Service Information

1996-12-03
HR6371
HR6374
HR6377
DAP135

Domestic Appliances and Personal Care

Safety screw.

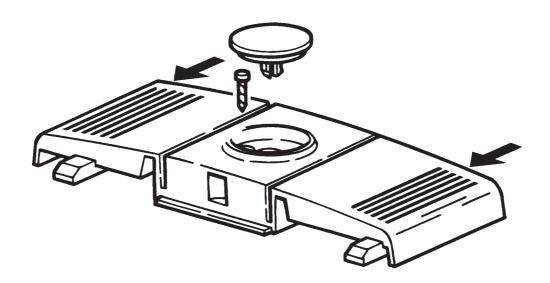
These non electronic vacuum cleaners with cordwinder are provided with the pedal of the electronic version and in stead of a control knob a flat closed cap has been mounted.

To comply with all safety requirements, **underneath the flat closed cap** a screw has to be used as for the versions with electronics.

There have been produced a number of appliances without the screw, if these appliances are offered for service please **add the screw**.

Appliances without a screw can be recognised due to the fact that the pedal can be lifted up in the middle. By unlocking the two nocks at the corners the pedal can be removed with the flat closed cap remaining in its place.

To enable you to remove the flat closed cap for service purposes we advice you to remove the flat closed cap by means of a sucking-cup.
